SERVICE BULLETIN

APPLICABILITY: 2013-14MY BRZ

High-Pitched "Chirp", "Squeak" or "Cricket"

NUMBER: 09-54-12R DATE: 10/03/12

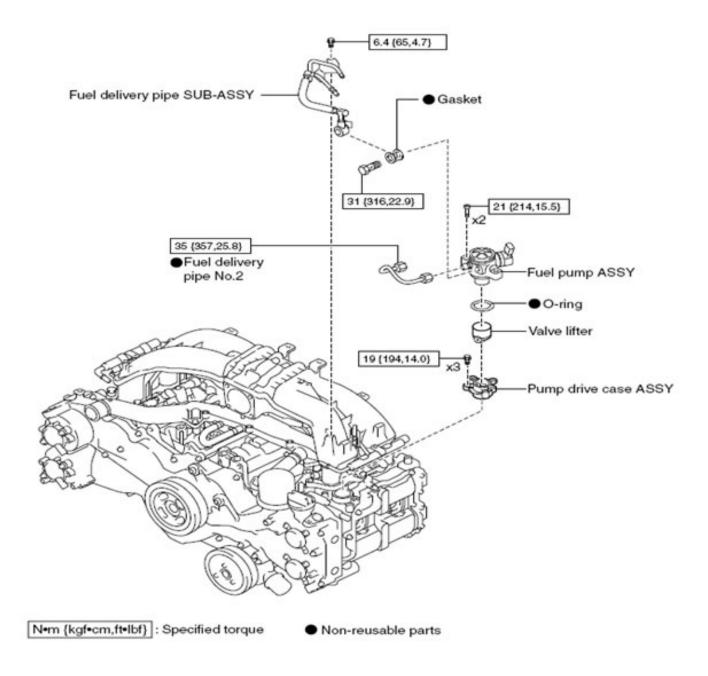
A series of production changes have been made to the high-pressure fuel pump to reduce the occurrence of the sound which include:

- a change to an internal fuel passage
- a change to the shape of the plunger stopper
- a change to the pulsation dampener assembly

COUNTERMEASURE	VIN NUMBER	PRODUCTION DATE
1) Increase of clearance for sub-chamber fuel passage		
2) Shape change of plunger stopper	E*601536	Mid-February, 2013
3) Change to the pulsation dampener assembly

Once the sound has been confirmed, the high-pressure fuel pump assembly must be replaced to remedy the condition.
